Backfeed v211

145.3.8.8 Backfeed Reflected voltage

Figure 145–29a — Reflected voltage requirement with one positive pair connected

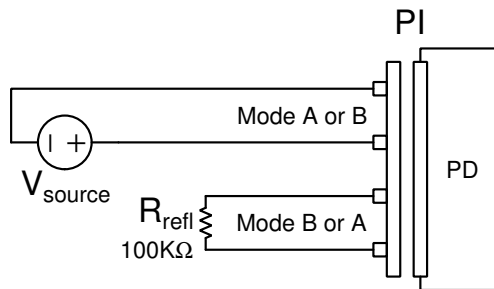
For a single-signature PD, when any voltage in the range of 0 V to $V_{\text{Port_PD-2P max}}$ is applied per any of the valid 2-pair configurations, defined in Table 145–20, that have only a single pair connected to positive V_{PSE} (see Figure 145–29a), the voltage on the Mode not connected to the voltage source, with a 100 k Ω resistor connected across that Mode, shall not exceed V_{refl} as defined in Table 145–29.

For a single-signature PD, when any voltage in the range of 0 V to 10.1 V is applied per any of the valid 2-pair configurations, defined in Table 145–20, including those with two pairs connected to positive V_{PSE} (see Figure 145–29a and Figure 145–29b), the voltage on the Mode with at least one pair not connected to the voltage source, with a 100 k Ω resistor connected across that Mode, shall not exceed V_{refl} as defined in Table 145–29.

For a dual-signature PD, when any voltage in the range of 0 V to $V_{\text{Port_PD-2P max}}$ is applied per any of the valid 2-pair configurations, defined in Table 145–20, including those with two pairs connected to positive V_{PSE} (see Figure 145–29a and Figure 145–29b), the voltage on the Mode with at least one pair not connected to the voltage source, with a 100 k Ω resistor connected across that Mode, shall not exceed V_{refl} as defined in Table 145–29.
